August 12, 2008

SUBJECT: SALEM NUCLEAR GENERATING STATION UNITS 1 AND 2: REPORT ON RESULTS OF STAFF AUDIT OF CORRECTIVE ACTIONS TO ADDRESS GENERIC LETTER 2004-02 (TAC NOS. MC4712 AND MC4713)

**Figure 3.6-1 CCI Test Loop**

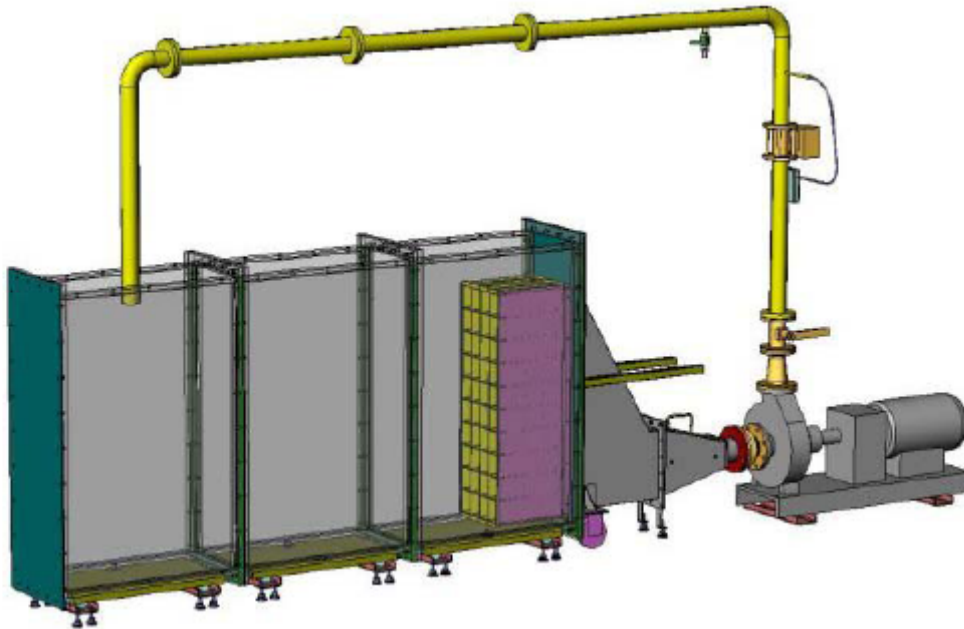
Test 2a was a repeat of Test 2, except that a plate was installed in the test flume with an 8 mm gap between the plate and the side wall of the flume. Although not shown in Figure 3.6-1, this plate can be seen in Figure 3.6-2 upstream of the strainer module. The plate is installed and a small gap is maintained between the vertical side of the tank and the edge of the plate. All flow is forced through this gap resulting in increased turbulence in the tank and increased flow parallel to the face of the strainer, upstream of the strainer module. The gap introduced enough turbulence into the tank that debris settlement was minimal. This test was run for about two hours after the last debris addition, allowing about 15 tank turnovers. However, the peak head loss of 8.3 ft occurred about one hour after the last debris batch was added. Immediately following the last addition, the head loss decreased quickly to about 7.2 ft and then drifted down slowly to a head loss of 6.9 ft at test termination. It is likely that the rapid decrease in head loss was due to channeling or bore-hole formation initiated by the high differential pressure. The licensee noted that with higher turbulence and, therefore, higher transport, the peak head loss value increased before the theorized channeling/bore-hole phenomena occurred.

- During testing, the debris was introduced within one ft of the strainer surface. In the plant, most debris would have to travel a significant distance to reach the strainer, allowing more time for the debris to settle.
- The test mock up did not include the back side of the strainer--the side facing the outer containment wall. (See Figure 3.6-2 for a conceptual test set up with this configuration.) The back side of the strainer would likely benefit from significant settling with the front side acting as a debris interceptor.
- In the plant, there would be significant flow parallel to the face of the strainer (at 90 degrees to the pocket openings). Therefore, a turbulence condition would exist which would tend to agitate debris off the floor, onto only a few of the modules and only onto the front sides of those modules in the plant.

**Figure 3.6-2 CCI Test Loop for Future Tests**

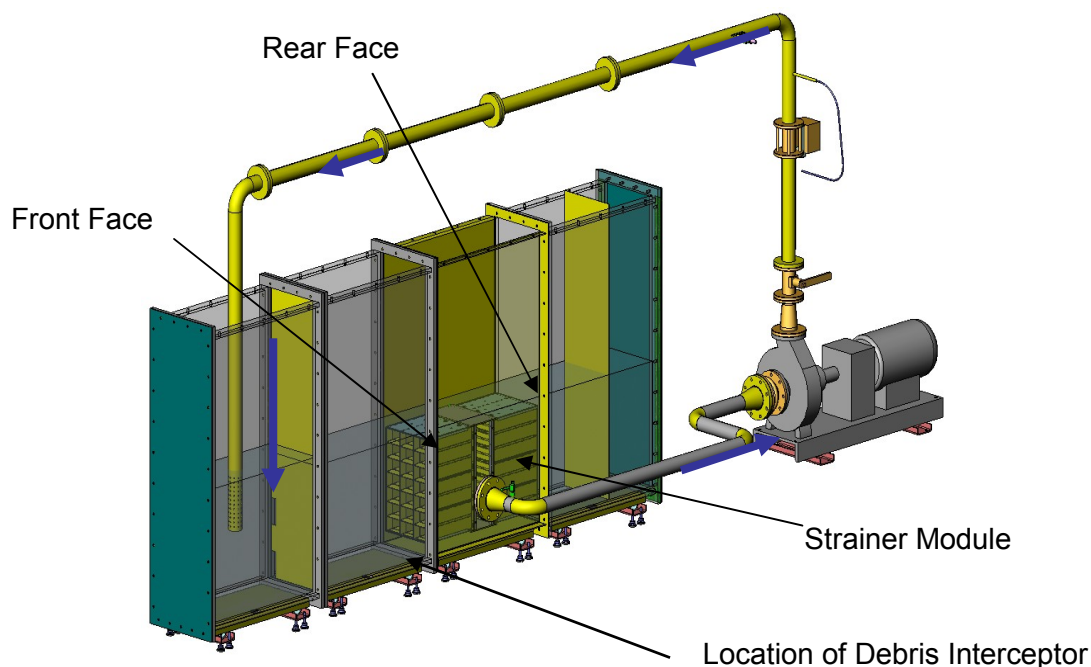
proceeding with a new testing program that will provide a test setup that is more prototypical of the plant arrangement (Figure 3.6-2). A final evaluation of the acceptability of the head loss for Salem cannot be completed by the staff until the testing is completed and a finalized head loss calculation is provided for review. The need for the licensee to provide the results of the updated head loss testing and the associated finalized head loss calculation is designated as **Open Item 3.6-1** and is presented in detail in Section 3.6.6.
